STD Comment Form for 1st Posting of Balance Resources and Demand Standard

Note – This form is to comment on version 1 of the Balance Resources and Demand Standard.

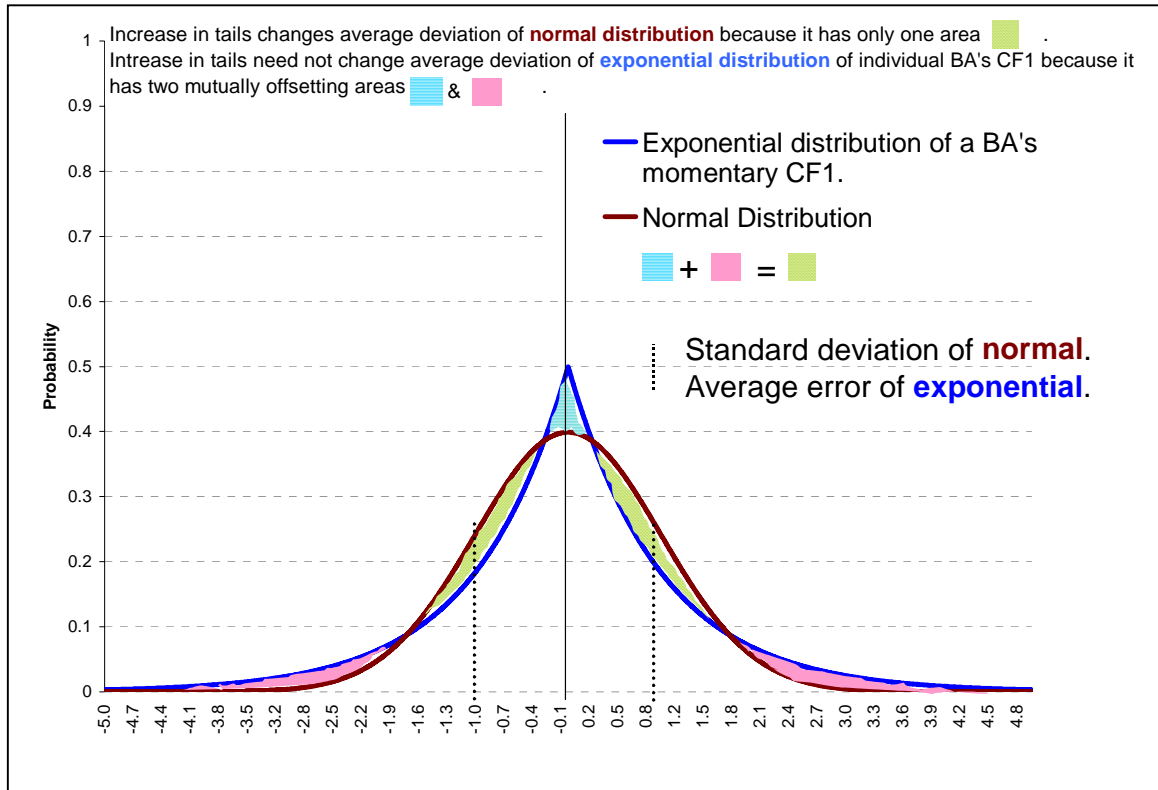
There is no sound technical basis for the DEM concept or the proposed DEM measures, but a monthly CPM1 measure, while better than the proposed DEM measures, would be technically incompatible with annual CPM-1.

NO TECHNICAL BASIS. There is no sound technical basis whatsoever for the compliance threshold value of 15, nor for any value for that matter. It is not an "event" measure at all as formulated: as formulated it detects "*usual operating*" errors. Also it assumes the wrong statistical distribution over time of momentary CPM Compliance Factor performances.

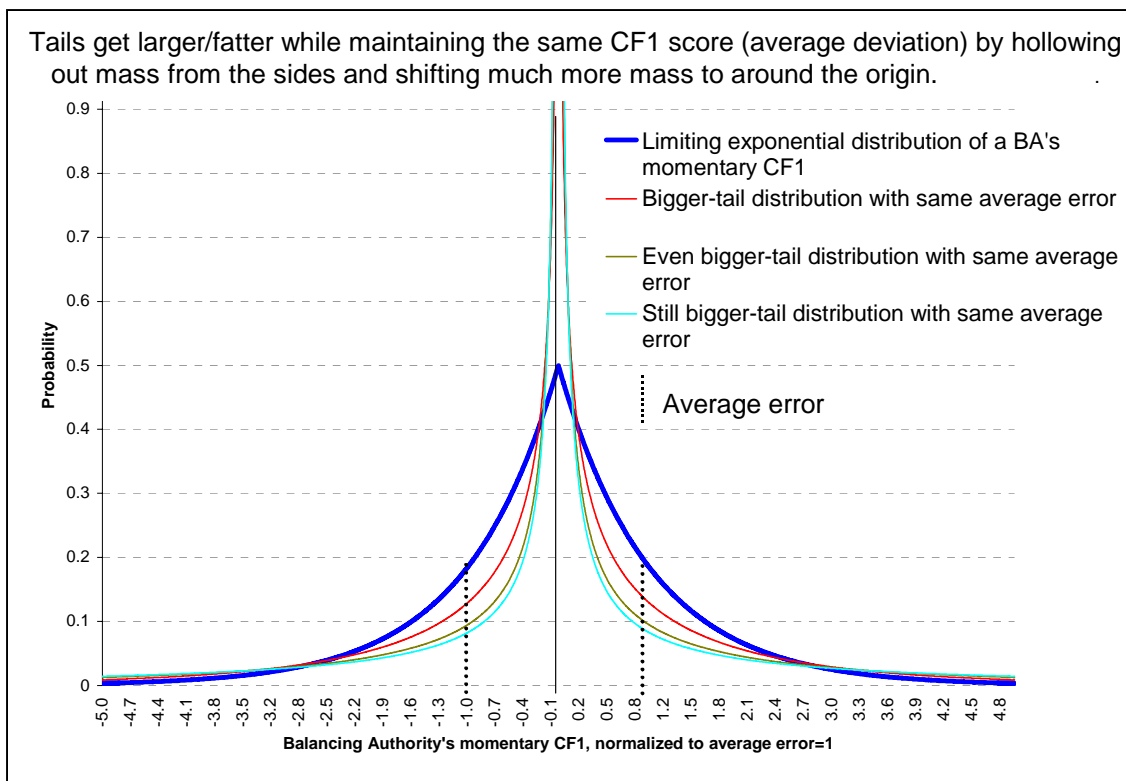
- FOR CPM COMPLIANCE A HUGE NUMBER OF EXTRA TIGHT ERRORS (CF1s) CAN COMPENSATE FOR A BIG MOMENTARY ERROR (CF1).** In other words,
 - A BALANCING AUTHORITY** can maintain the same standard deviation of error when the relative number of his big errors increases as long as the relative number of his tiny errors increases exponentially more. He can expand the base of the volcano while keeping the mass of the volcano unchanged, as long as the funnel of the volcano narrows and spikes ever upward, making the volcano thinner and steeper. In other words, he can make up for big errors by also increasing, but by exponentially more, the proportion of tiny errors, namely by tightening his control of usual operating errors. So the number of big errors he can incur, without deteriorating the standard deviation of

error, is limited by how much he can tighten his control of usual operating errors the rest of the time.

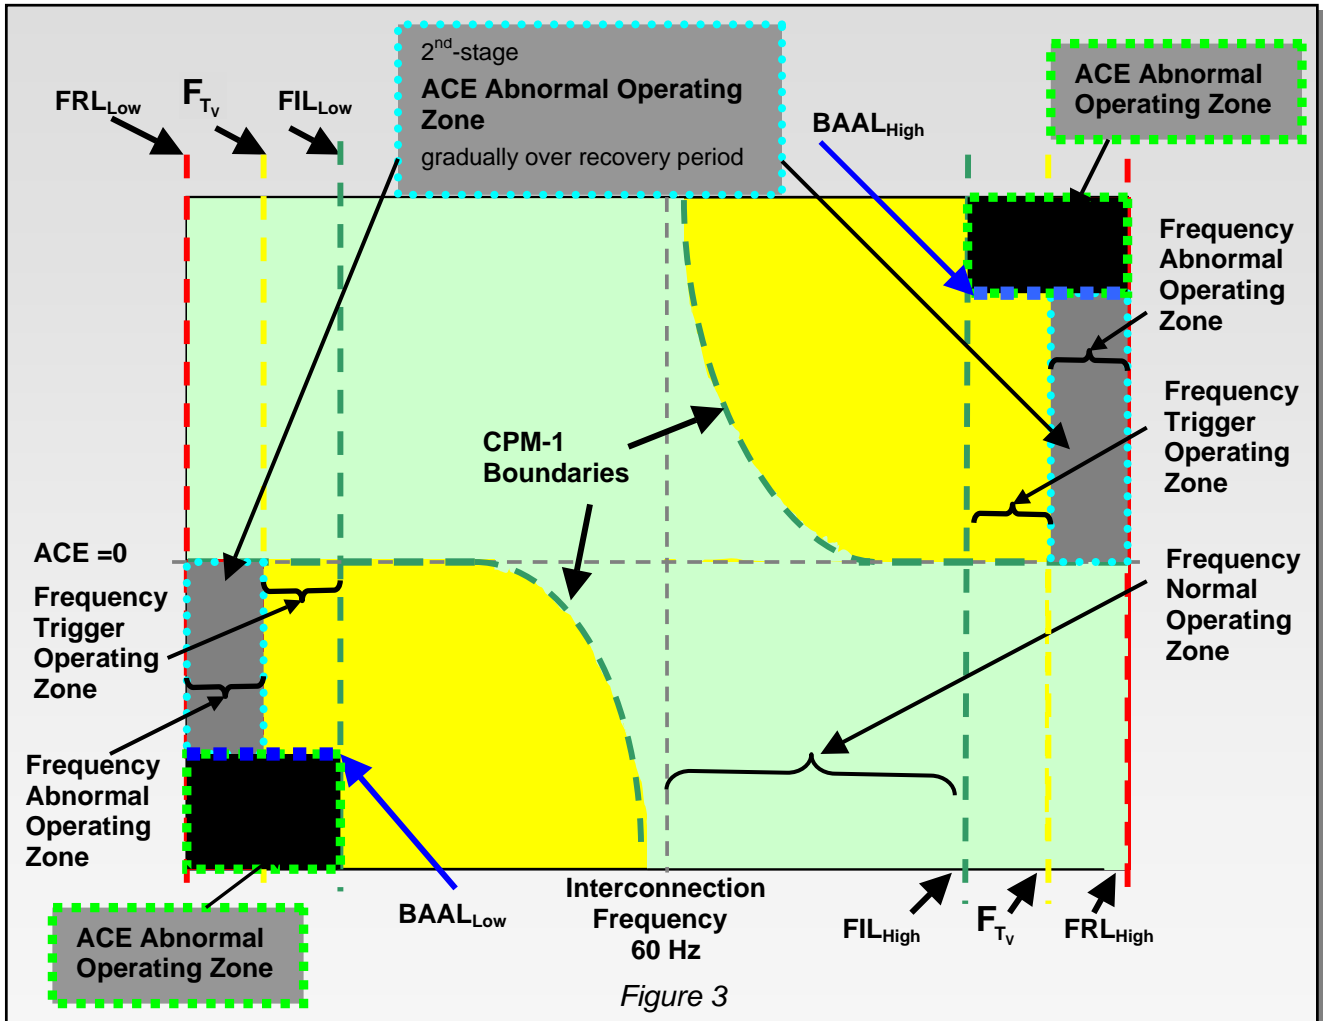
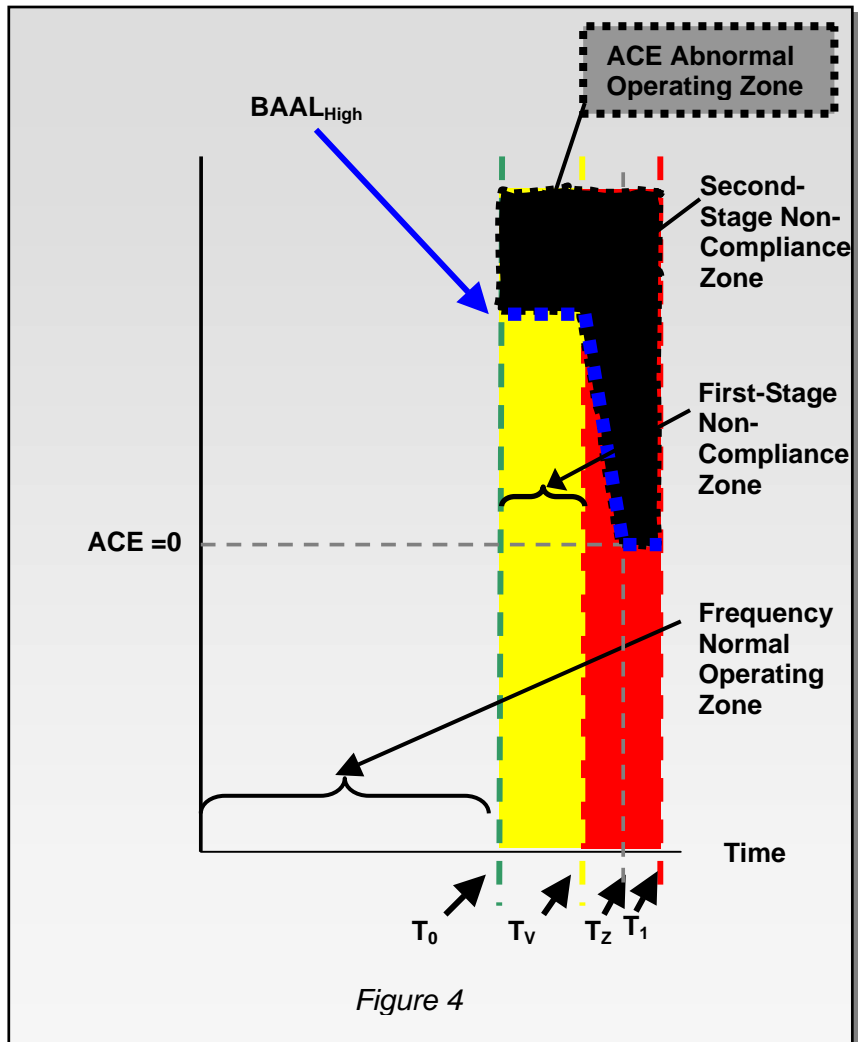
THE REQUIREMENT AND MEASURES ARE UNNECESSARY, and would *unnecessarily complicate compliance* assessment of Balancing Authorities to a 2-dimensional matrix from the presently proposed 1-dimensional scale of %-of-instructed-ACE-reduction performed in section 5 of requirement 304. A non-compliant Balancing Authority's geographic proximity to the other non-compliant Balancing Authorities, reflected in whether the Balancing Authority's Reliability Authority is a cause of the violation, is irrelevant both to that Balancing Authority's impact on Interconnection frequency and to the Reliability Authority's performance of its task. The Reliability Authority has no control over how many of the non-performing Balancing Authorities lie in its jurisdiction. Furthermore, while several Reliability Authorities could collectively be the cause of a violation without each individually being a cause, for example if each contained just one of a number of offending Balancing

Authorities, the violation is no less serious than if one Reliability Authority is the cause. Similarly for the seriousness of a violation, whether caused by a single event, or by a combination of poor operating performances by a group of Balancing Authorities. But second-stage non-compliance is badly defined.

THE SECOND STAGE OF NON-COMPLIANCE BY BALANCING AUTHORITIES IS DISCONTINUOUS AND DESTABILIZING FOR REQUIRING for compliance *instantaneous* elimination of any ACE in the direction of the violation. The second stage of non-compliance occurs whenever the Frequency Abnormal Limit is breached or the recovery time exceeds the Frequency-Limit Violation Time limit. The discontinuity causes frequency instability in two ways:

STIPULATE A SECOND-STAGE ABNORMAL-LIMIT VIOLATION PERIOD AND DEFINE THE "ACE NORMAL OPERATING ZONE" RELATIVE TO FREQUENCY AND RELATIVE TO TIME. The ACE Abnormal Operating Zone over that second-stage abnormal violation period can be defined *only relative to time*, and not relative to frequency, as a diagonal line sloping downward from BAAL at the beginning T_V of the period to $ACE=0$ at T_Z during the period just long enough for Balancing Authorities suddenly non-compliant through no fault of their own to reasonably comply. Accordingly, Figure 3 of the definitions needs to be redrawn to display the ACE Abnormal Operating Zone, to relabel the frequency limits, and to properly depict the CPM-1 boundaries which decay to $ACE=0$ well before reaching the Frequency Trigger Limit (Frequency Intervention Limit, FIL), and a new Figure 4 needs to be added showing ACE relative to time, depicting the ACE Abnormal Operating Zone, and labeling the frequency limits.
